[Docket No. 2003-CE-43-AD; Amendment 39-13328; AD 2003-20-10]

Airworthiness Directives; Raytheon Aircraft Company Beech Models 1900, 1900C, and 1900D Airplanes

2003–20–10 Raytheon Aircraft Company: Amendment 39–13328; Docket No. 2003–CE–43–AD.

Figure 1

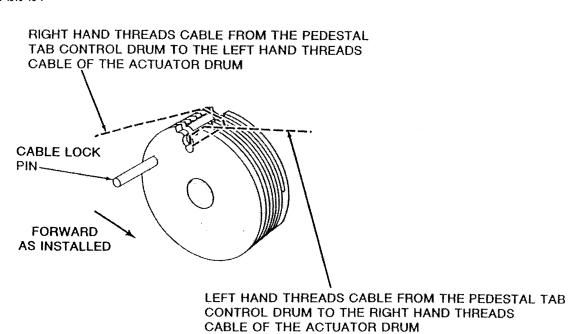
- —The figures in the applicable maintenance manuals depict the elevator trim cable drum at 180 degrees from the installed position and show the open, keyed side of the drum instead of the flat side of the drum. Following these figures when installing the control cables on the forward control cable drum could reverse the action of the elevator manual trim system; and
- -The existing procedure can be enhanced by visually confirming the trim wheel position and the trim tab position are consistent. Such a check would detect and correct any problems with the elevator trim system installation before problems occur during operation.

Although the figures (figure 9 for the 1900/1900C and figure 201 for the 1900D) in the existing maintenance manuals are incorrectly depicted, following the step-by-step written instructions in the existing procedure and referring to the orientation of the parts removed would result in the correct installation and action of the elevator trim system.

Actions	Compliance	Procedures
 (1) Using pen and ink, mark the applicable figure in the maintenance manual as referenced below. The depiction in the referenced figures is incorrect for the elevator trim drum only and depicts the cable drum at 180 degrees from the installed position and shows the open, keyed side of the drum instead of the flat side of the drum. Insert corrected figure (Figure 1 of this AD) into the applicable maintenance manual and identify it accordingly: (i) Figure 9 of Chapter 27–10–00 of the Model 1900/1900C Airliner Maintenance Manual (114–590021–7B) Clearly note in pen that existing portion of Figure 9 is correct for the aileron trim drum only and insert corrected figure (Figure 1 of this AD) marked in pen as correct for the elevator trim drum only; or 	Before the next time you have maintenance done on the elevator trim system.	As specified in Raytheon Safety Communiqué No. 234, dated September 2003.

Actions	Compliance	Procedures
 (ii) Mark out Figure 201 of Chapter 27–30–04 of the Model 1900D Airliner Maintenance Manual (125–590000–15). Insert corrected figure (Figure 1 of this AD) (2) Incorporate the applicable temporary revision into the maintenance manuals as follows: (i) Temporary Revision No. 27–5 to the Model 1900/1900C Airliner Maintenance Manual: Revised ELEVATOR TRIM OPERATIONAL CHECK; or (ii) Temporary Revision No. 27–9 to the Model 1900D Airliner Maintenance Manual: Added MANUAL ELEVATOR TRIM 	Before the next time you have maintenance done on the elevator trim system.	As specified in Raytheon Safety Communiqué No. 234, dated September 2003.
OPERATIONAL CHECK. (3) Do the elevator trim operational check that is specified in the applicable maintenance manual and temporary revisions to the maintenance manual as referenced in paragraph (e)(2) of this AD	Prior to further flight after each time you have maintenance done on the elevator trim system.	As specified in Raytheon Safety Communiqué No. 234, dated September 2003: and Temporary Revision No. 27–5 to the Model 1900/1900C Airliner Maintenance Manual: Revised ELEVATOR TRIM OPERATIONAL CHECK; or Temporary Revision No. 27–9 to the Model 1900D Airliner Maintenance Manual: Added MANUAL ELEVATOR TRIM OPERATIONAL CHECK, both dated September 12, 2003, as applicable.
